SERVICE LETTER SL44 66-12107

66-12107 SPACER, FWD FUSELAGE FITTING, AEROCET MODEL 6650 FLOAT INSTALLATION, KODIAK AIRCRAFT

66-12107 ISOMETRIC VIEW

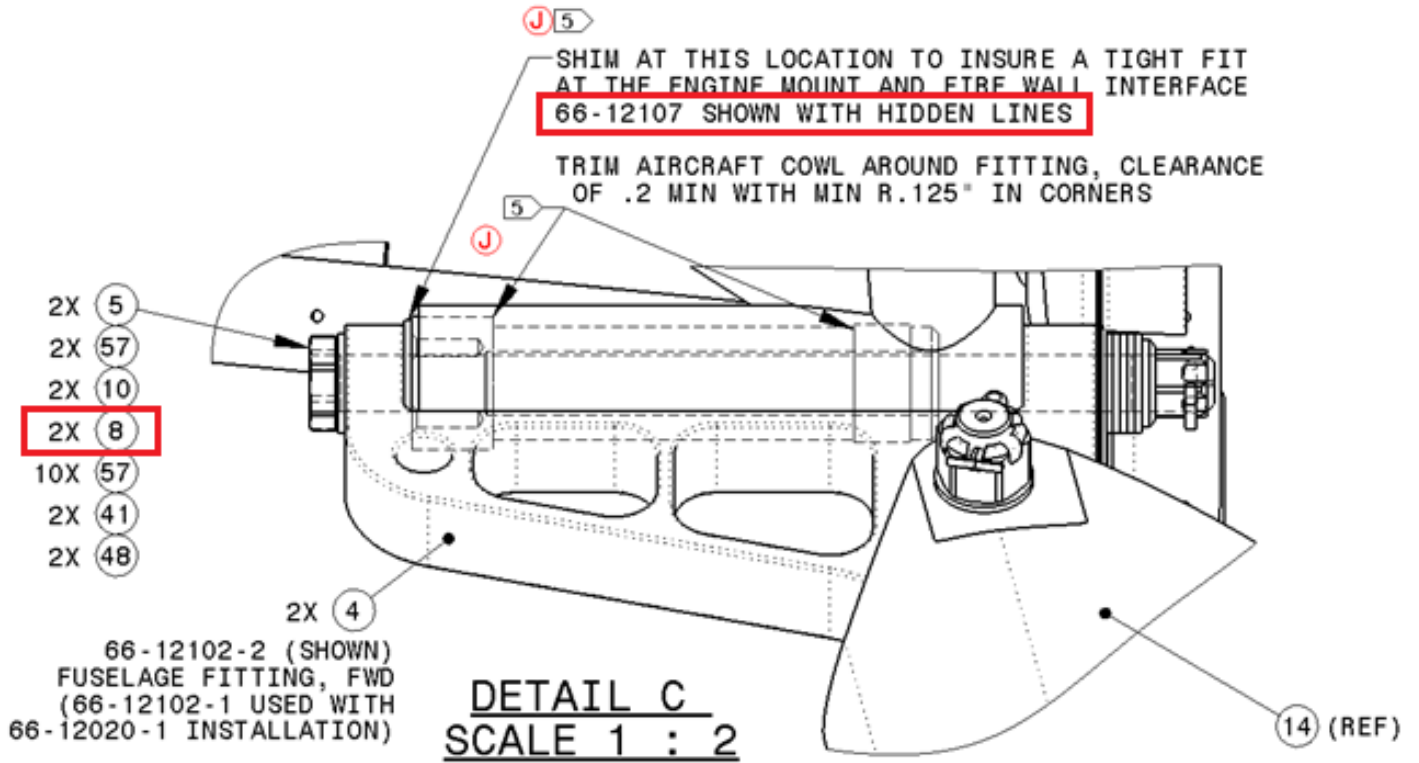
To accommodate the tolerance of the engine mount, Aerocet redesigned the 66-12107 spacer, ultimately manufacturing them in three different outside dimension sizes. The -1 is the smaller of the spacers and the -3 is the largest.

The installer or mechanic is to use the largest dash number (66-12107-1 through -3) that will fit inside the engine mounts.
